Access Compliance Report

Public Rights-of-Way

(Pedestrian Signals)

Intersection ID: N/A	Main Street:	Cross Street: N/A	Location: N/A
ADA ID: 0D86F0D7CC90	Signal Type: Two Push Buttons-APS	Overall Compliance: No	Severity Score: BTN 1:N/A BTN 2: N/A No BTN: N/A
Codes/Mitigation Info/Possible Solution		Field Measurements/Component Compliance

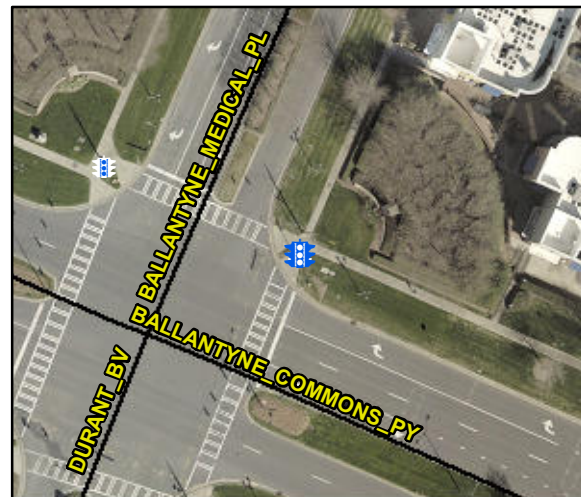
Compliance	Description	Data	Compliance	Description	Data
	Button Count	Button2	N/A	Distant to Additional Button (in)	N/A
	Additional Button Present?	No		Additional Button ID	N/A
N/A	Signal Buttons Required?	N/A	N/A	Additional Ped Posts Required	N/A
	How Many Ped Street Xings?	2		Located In An Island/Median?	No
N/A	B 1 Sign Present?	Yes	N/A	B 2 Sign Present?	Yes
Yes	B 1 Sign Purpose?	Yes	Yes	B 2 Sign Purpose?	Yes
Yes	B 1 Sign Lettering & Contrast?	Yes	Yes	B 2 Sign Lettering & Contrast?	Yes
Yes	B 1 Parallel To XWalk?	Yes	Yes	B 2 Parallel To XWalk?	Yes
Yes	B 1 PAR to Button?	Yes	Yes	B 2 PAR to Button?	Yes
Yes	B 1 PAR to XWalk?	Yes	Yes	B 2 PAR to XWalk?	Yes
Yes	B 1 Clear Floor Space?	Yes	Yes	B 2 Clear Floor Space?	Yes
N/A	B 1 FWD Approach?	Yes	No	B 2 FWD Approach?	No
N/A	B 1 FWD Approach Constrained?	No	N/A	B 2 FWD Approach Constrained?	N/A
No	B 1 FWD Approach Reach (in)	17.0	N/A	B 2 FWD Approach Reach (in)	N/A

N/A	B 1 FWD Approach Width (in)	N/A	N/A	B 2 FWD Approach Width (in)	N/A
N/A	B 1 FWD Approach Obstruction?	Yes	N/A	B 2 FWD Approach Obstruction?	N/A
N/A	B 1 FWD Approach Obstruction Dist (in)	17.0	N/A	B 2 FWD Approach ObstructionDist (in)	N/A
N/A	B 1 PARA Approach?	Yes	No	B 2 PARA Approach?	No
N/A	B 1 PARA Approach Constrained?	No	N/A	B 2 PARA Approach Constrained?	N/A
No	B 1 PARA Approach Reach (in)	17.0	N/A	B 2 PARA Approach Reach (in)	N/A
N/A	B 1 PARA Approach Width (in)	N/A	N/A	B 2 PARA Approach Width (in)	N/A
N/A	B 1 PARA Approach Obstruction?	Yes	N/A	B 2 PARA Approach Obstruction?	N/A
N/A	B 1 PARA Approach Obstruction Dist (in)	17.0	N/A	B 2 PARA Approach ObstructionDist (in)	N/A
Yes	B 1 Clear Floor Space Slope (%)	9.5	Yes	B 2 Clear Floor Space Slope (%)	2.5
No	B 1 Clear Floor Space XSlope (%)	8.6	No	B 2 Clear Floor Space XSlope (%)	5.7
N/A	B 1 PAR Slope (%)	9.5	N/A	B 2 PAR Slope (%)	2.5
Yes	B 1 Height (in)	39.0	Yes	B 2 Height (in)	38.0

Yes	B 1 Clear Xing Direction?	ClearlyMarked	Yes	B 2 Clear Xing Direction?	ClearlyMarked
	B 1 Crossing Direction	To NW		B 2 Crossing Direction	To SW
Yes	B 1 DistanceTo XWalk (in)	0.0	Yes	B 2 DistanceTo XWalk (in)	0.0
No	B 1 DistanceTo Curb (in)	106.0	No	B 2 DistanceTo Curb (in)	117.0
Yes	B 1 Diameter (in)	2.0	Yes	B 2 Diameter (in)	2.0

Possible Solutions: Replace Signal Push Button With APS Button on New Post. Remove & Relocate Sign.

PROW/ADA: TMUTCD 4e.08, R404.2, R406.2, R404.7.3, , R404.7.1, R404.7.2
